SUBJECT: Addendum No. 1
Hiwassee Utilities Commission
Water Treatment Plant Concrete Clearwell Baffle Replacement

ADDENDUM NO. 1

CONTRACT DOCUMENTS, SPECIFICATIONS, AND QUESTIONS FOR THE WATER TREATMENT PLANT CONCRETE CLEARWELL BAFFLE REPLACEMENT

EXTRACT FROM
FEBRUARY 2023 INSPECTION

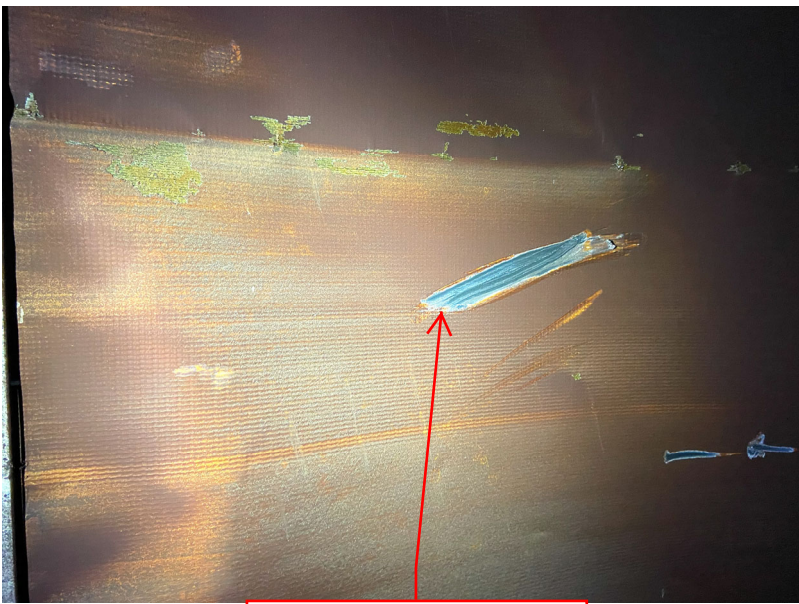
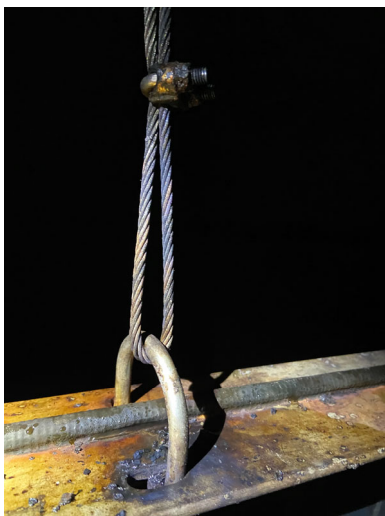
1. Question: Is there a recent inspection report available showing the condition of the exiting baffle curtains, hardware, cables, and the existing 36" inlet pipe?

Response: See attached "EXTRACT FROM FEBRUARY 2023 INSPECTION." (5 pages)

36" INLET LINE
NTS

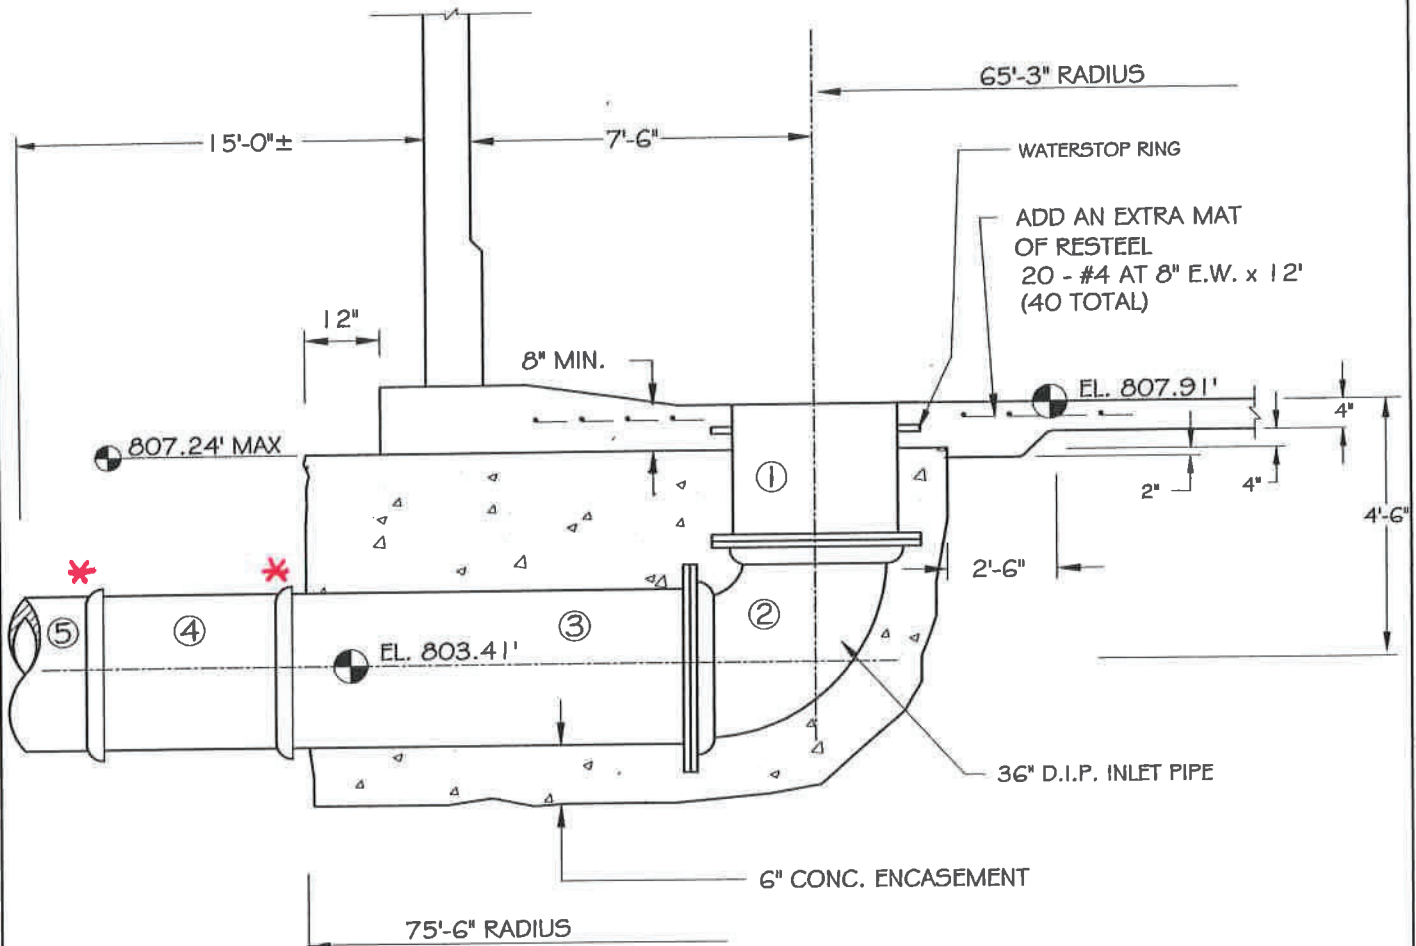
2. Question: Can you provide pictures or details of the existing 36" inlet pipe to be modified? Is the existing pipe buried in the floor, does it extend above the floor, or is there an existing 36" elbow?

4. Question: Figure 6 shows a floor depth of 8", but the tank construction drawings show a 4" floor. Please clarify what is required.

Response: See attached "36" INLET LINE". (1 page)

Response: The floor thickness at the inlet pipe is depicted in the original project submittal as 8 inches in the vicinity of the inlet. See attached "36" INLET LINE".
